Berlin, Germany, August 22 ~ 25, 2000

Agenda Item: AH21
Source: CWTS
To: TSG RAN WG1
Title: Dedicated Transport Channels for 1.28Mcps option
Document for: Discussion and Approval

Figure : Mapping of PDU onto the physical bearer(TTI= 20ms)

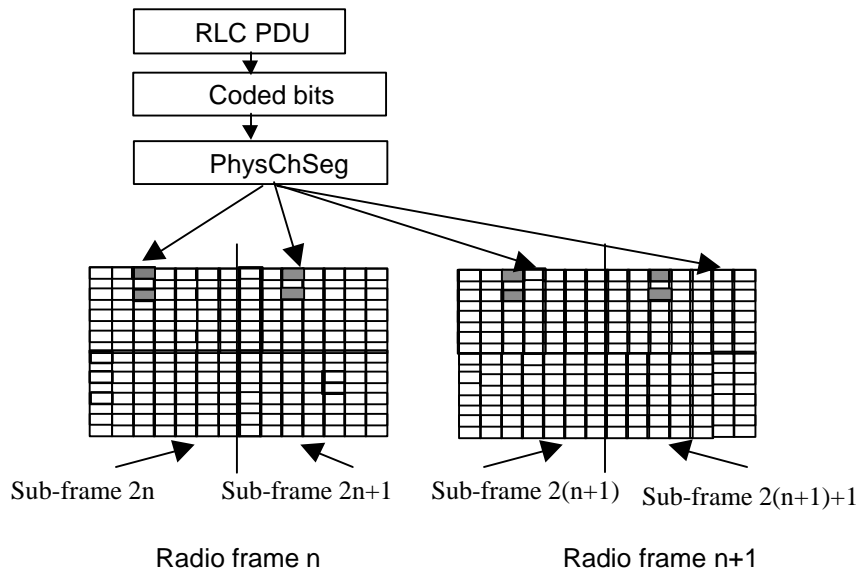
This paper shows the figure of Mapping of PDUs onto the physical bearer for 1.28Mcps TDD. It is different from that of 3.84Mcps TDD according to the subframe segmentation before the physical channel mapping.

It's proposed to discuss and include the following text proposal into the clause 8.1 Transmitter Power Control of working CR of TS25.221.
